Barrage Admiral et barrage du lac Downie - AAC
Contrat 5
Remplacement du système de vanne
CONTRAT 4547-928-714-0-C5

Addenda n° 2

Questions et réponses

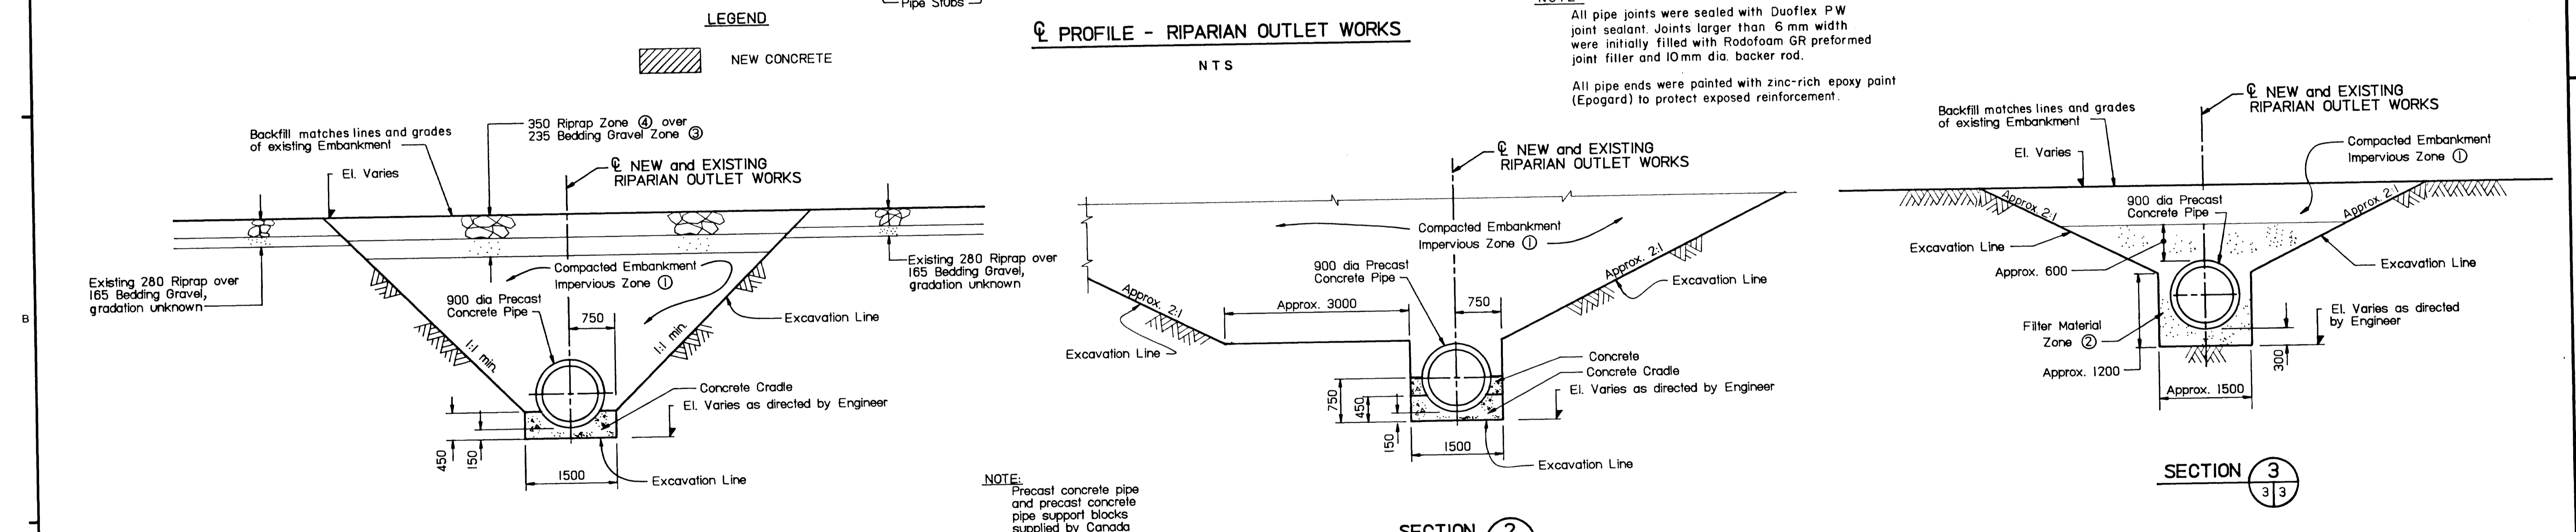
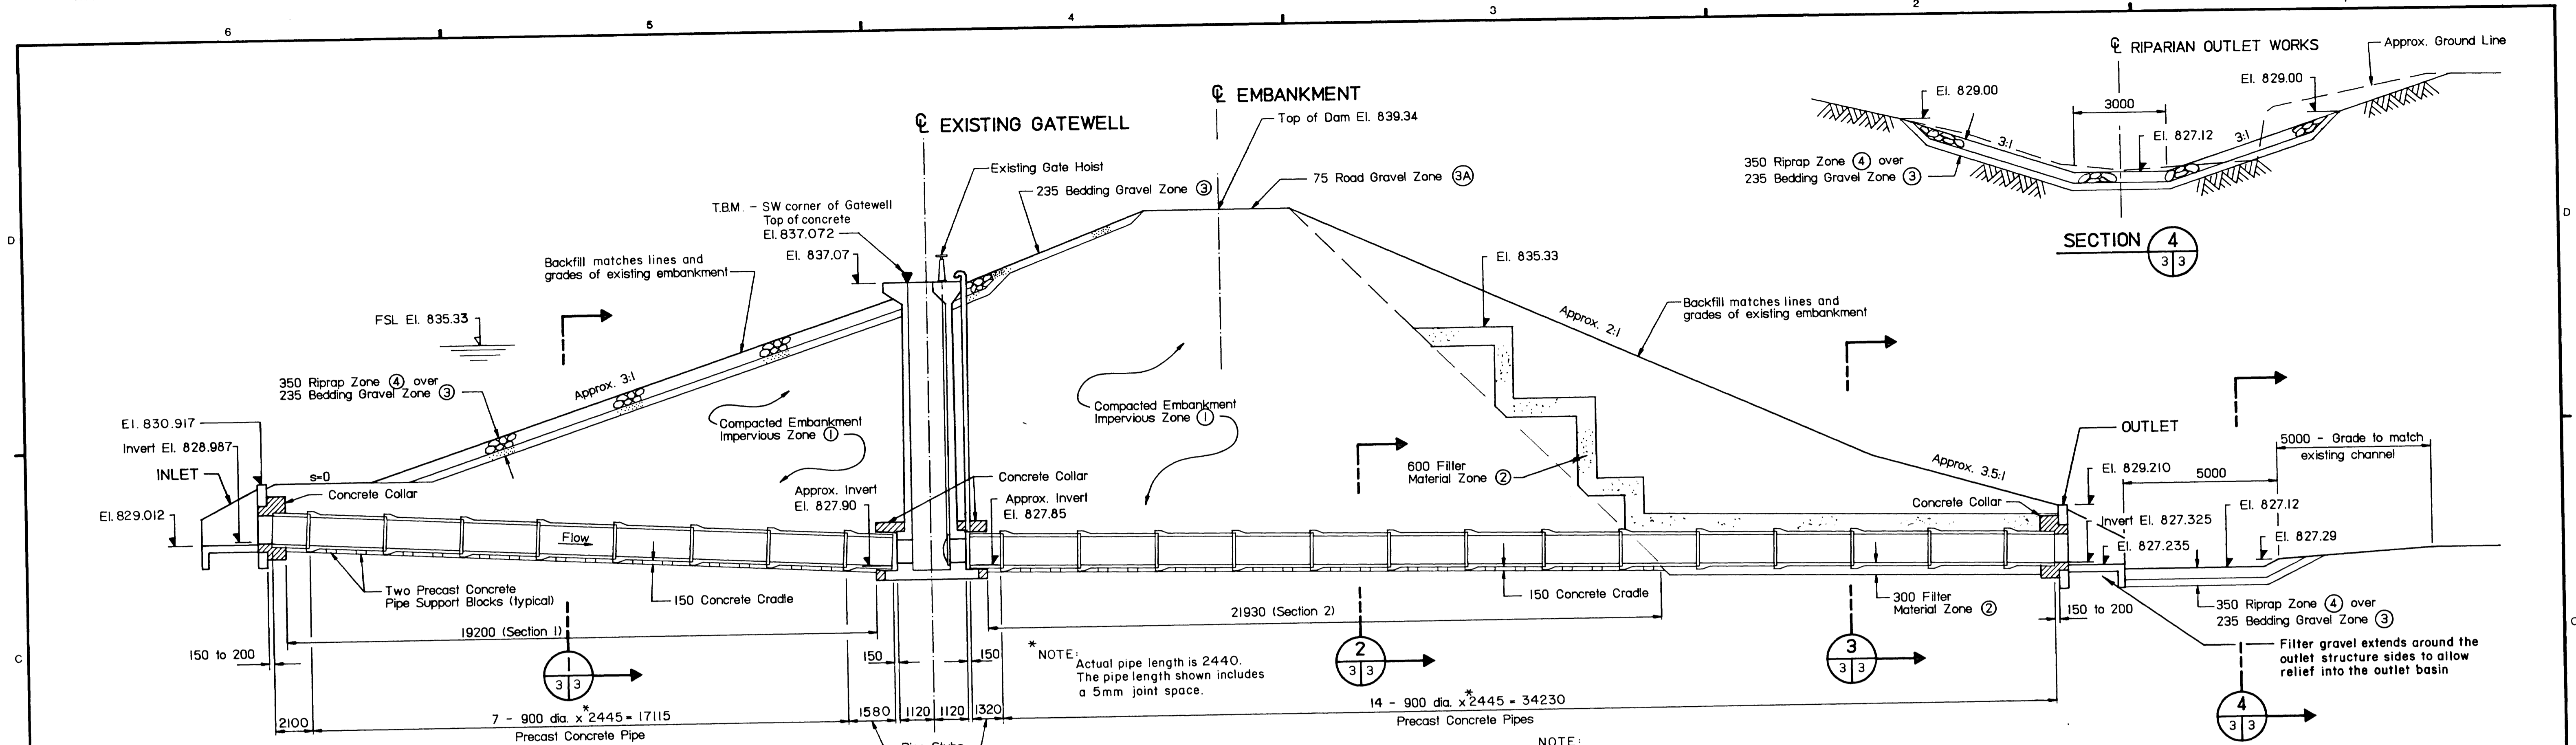
Q2 Est-ce que certains détails de l'entrée afin de pouvoir évaluer la conception d'une cloison?

R2 Voir les dessins ci-joints.
